PREAPPLICATION MEETING FOR
Renton High School Reconstruction
400 S 2nd St, Renton, WA 98057

PRE24-000148

**SUBJECT: Renton High School Reconstruction
400 S 2nd Street, Renton, WA
PRE24-000148**

DATE: May 23, 2024
TO: Pre-Application File No. 24-000148
FROM: Alex Morganroth, Principal Planner
SUBJECT: **Renton High School Reconstruction
(Parcel #0007200060 + 42 additional properties)**

CONCEPTUAL WATER MAIN EXTENSION LAYOUT
By: Abdoul Gafour - City of Renton Water Utility Engineering
May 21, 2024

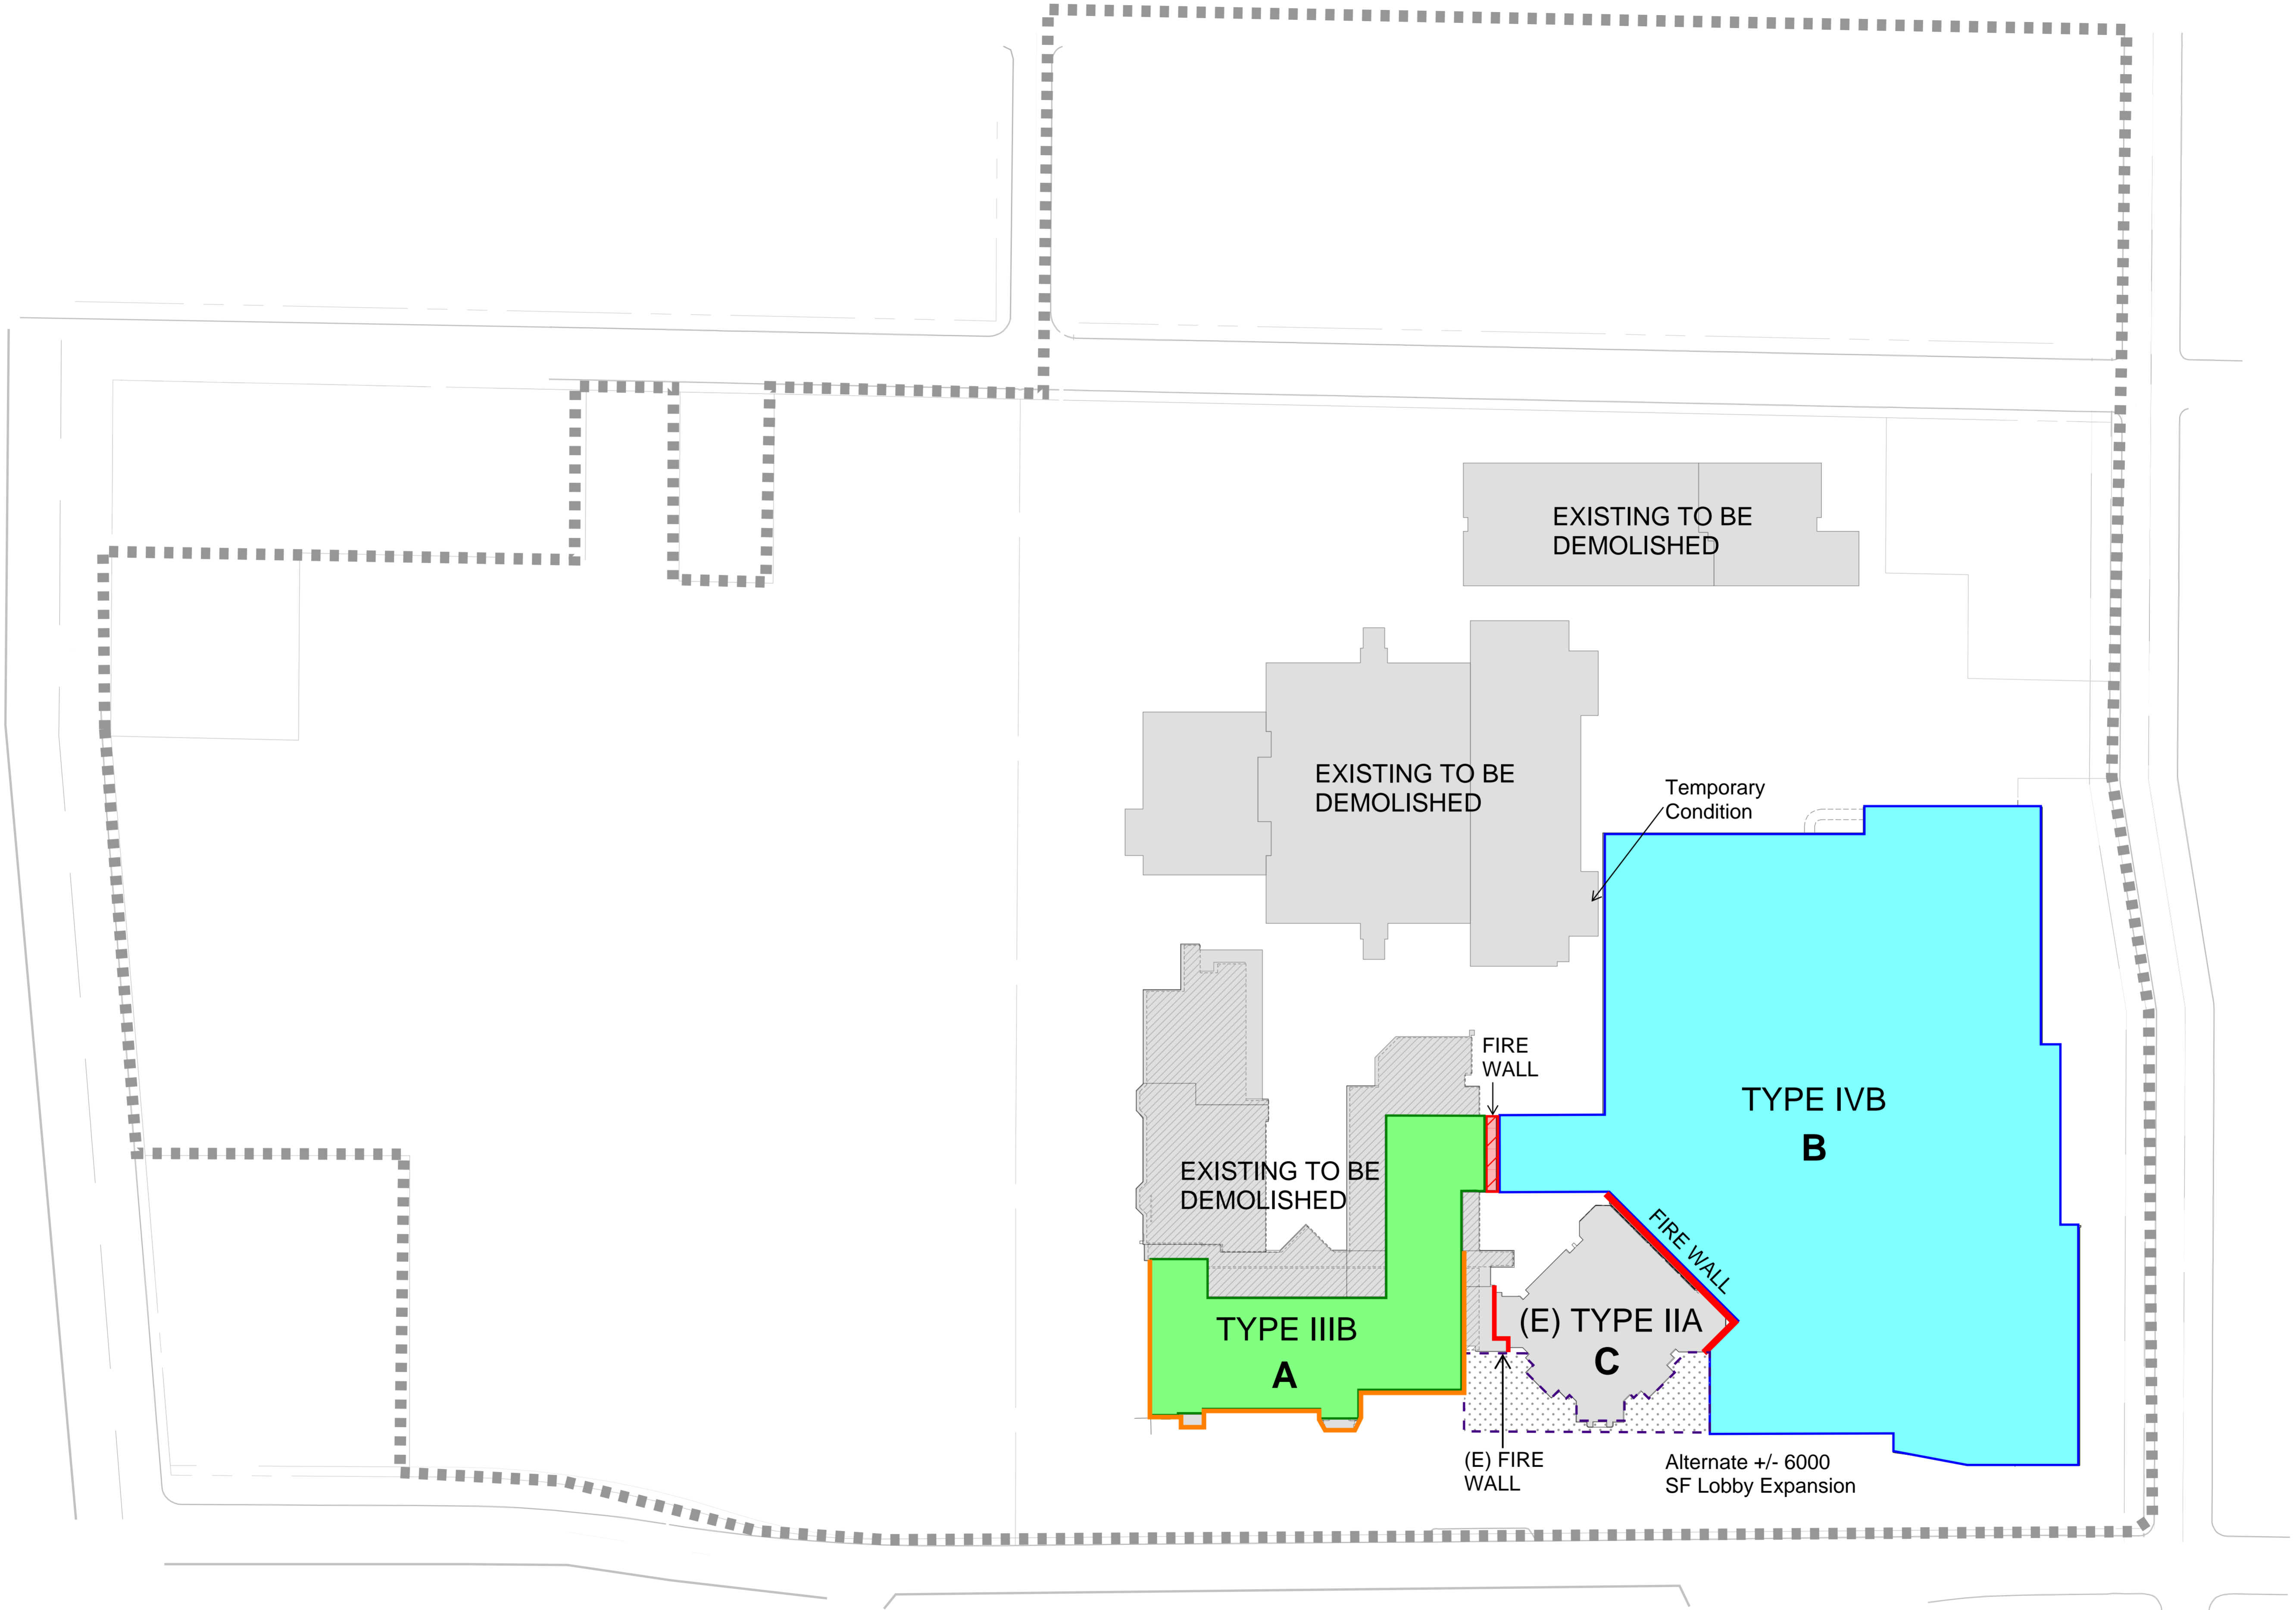
14. Based on the review of project information submitted for the pre-application meeting, Renton Regional Fire Authority has determined that the preliminary fire flow demand for the proposed development is 3,750 gpm including the use of an automatic fire sprinkler system throughout the buildings. The following developer's installed water main improvements will be required to provide domestic and fire protection service to the development including but not limited to (see attached conceptual water main improvement layout):

- a) A new 12-inch water main in Lake Ave S connecting the existing 12-inch water main in S 2nd St. to the existing 12-inch water main in S Tobin St.
 - b) A new 12-inch water main in Airport Way S connecting existing 12-inch water main in Logan Ave S to the new 12-inch water main in Shattuck Ave S.

- c) A new 12-inch water main to be located on site from Logan Ave S and within the proposed fire emergency access road north of the main gymnasium building and across the proposed parking lot and north driveway to Shattuck Ave S, and extending north in Shattuck Ave S to Airport Way S. The new main shall be connected to the existing 10-inch water main in Logan Ave S, to the existing 12-inch water main in S Tobin St, and to the new 12-inch water main in Airport Way S.

- d) Replacement of 2 short sections of existing 8-inch water main with new 12-inch water main at the intersection of S Tobin St and Logan Ave S.

- e) Installation of new hydrants to be located on-site and off-site to be connected to the above new water mains. The final number and location of the hydrants shall be determined by the Fire Authority and city water utility.
